AGENDA
LARIMER COUNTY BOARD OF COMMISSIONERS
Monday, February 8, 2016/3:00 P.M./Hearing Room

*2. TITLE: Gardner Subdivision Preliminary Plat

REQUEST: Approval of a Subdivision of a 7.64-acre parcel zoned FA-1 - Farming into two single-family residential lots and an appeal to Section 8.14.1.H of the Land Use Code (lot depth to width ratio)

FILE #: 14-S3262

LOT 2
± 2.94 Ac.

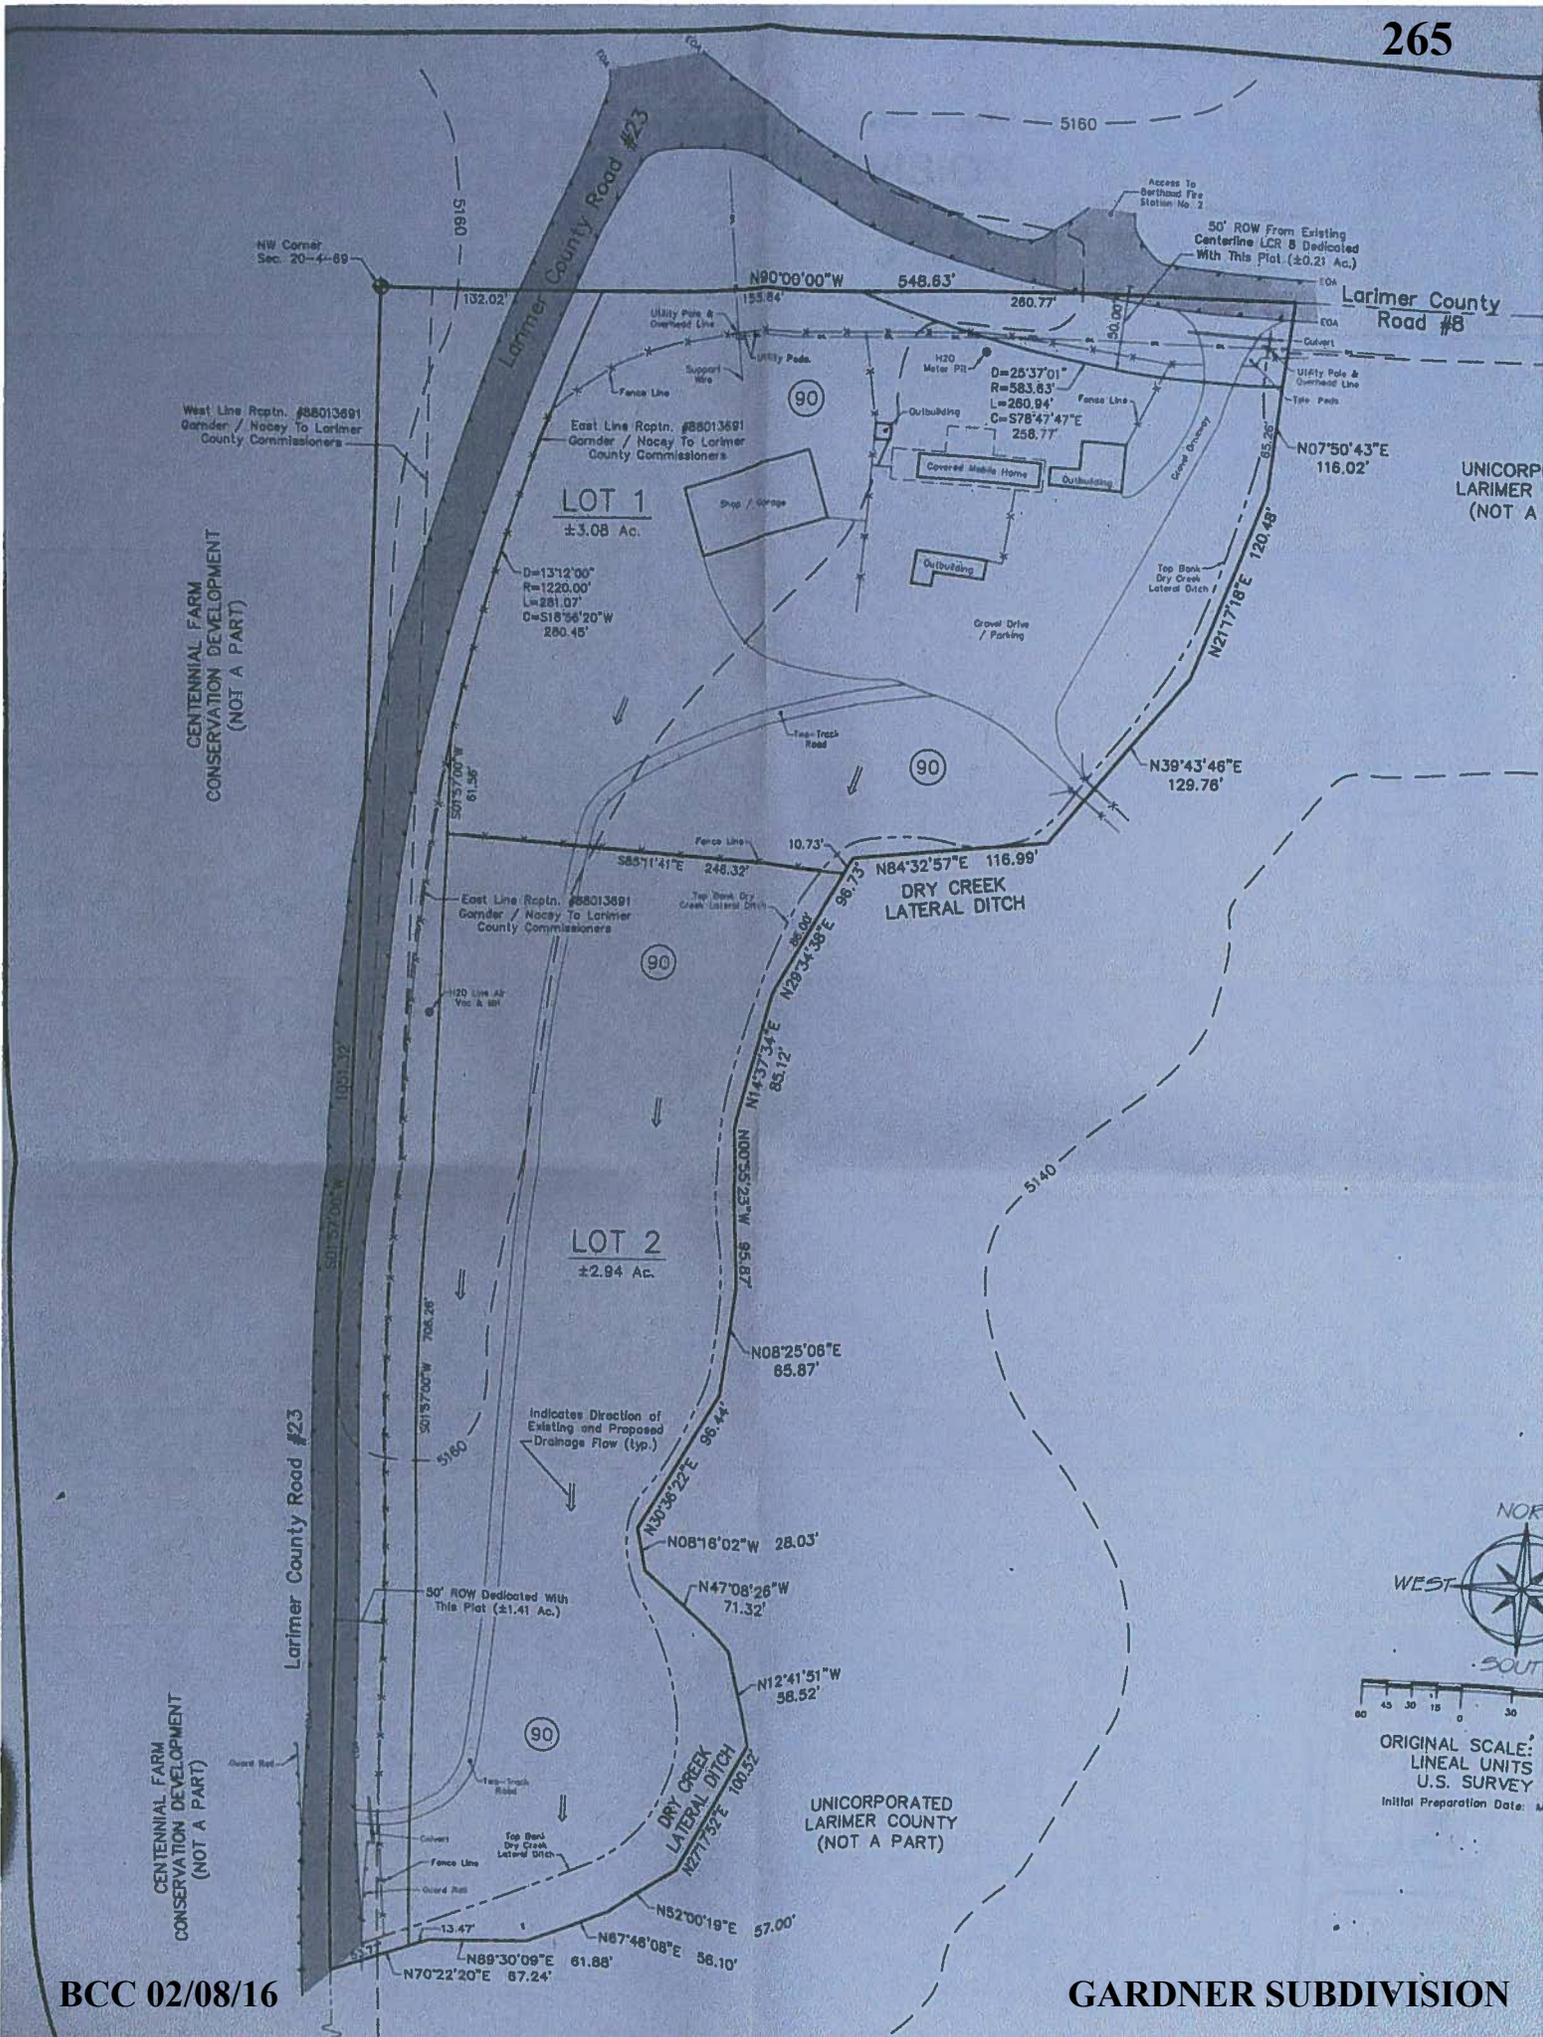
The application includes an appeal to Section 8.14.1.H of the Land Use Code which states that lots can not exceed a width-to-depth ratio of 1.5-to-1. The proposed Lot 2 does not meet this standard.

The proposed Lot 2 has a width-to-depth ratio of approximately 3.75-to-1.

The purpose of requiring a lot-to-depth ratio is to avoid creating long and shallow lots or narrow and deep lots. Those configurations tend to have more setback issues and less useable space than lots that have widths and depths that are proportionate.

In this case, the lot is already long north-to-south and relatively shallow east-to-west. The proposed subdivision does not change the configuration of the property but separates the southern portion of the property from the northern portion.

RECOMMENDATION: Based on the overall review of this project, the Development Services Team recommends approval of the appeal.
